**"New" Series V20
Composite Handle
Bracket
Enhances Better
Performance"**

Bulletin HY14-2705-B6/US

Series V20 Composite Handle Bracket Mobile Directional Control Valves

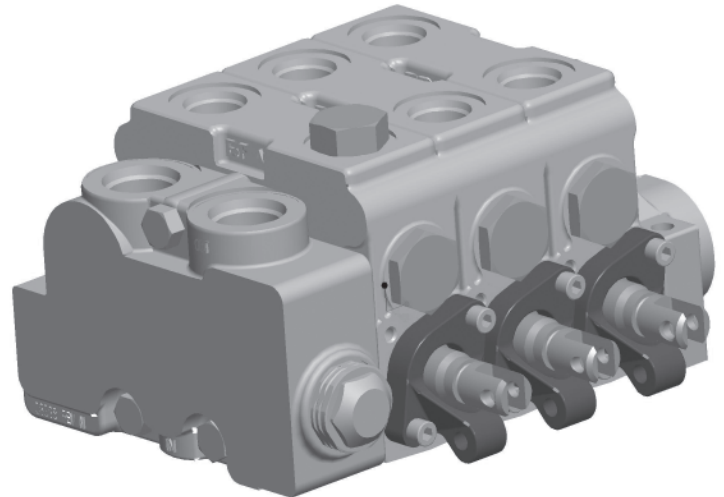
Parker Hydraulic Valve Division wants to inform you of a product update for the Series V20 product line. Starting in Mid-May 2006, you will begin receiving V20 distributor stock valve sections with a new composite handle bracket (01801003). This new bracket has the same physical shape as the current zinc bracket and has been thoroughly endurance tested. The composite material is corrosion resistant, and will eliminate galvanic corrosion.

This bracket uses the same two cap screws but the torque value has been changed to 4-6 ft lbs, the same torque as used on the composite bonnet (torque value for the Zinc and cast bracket is 10 ft lbs).
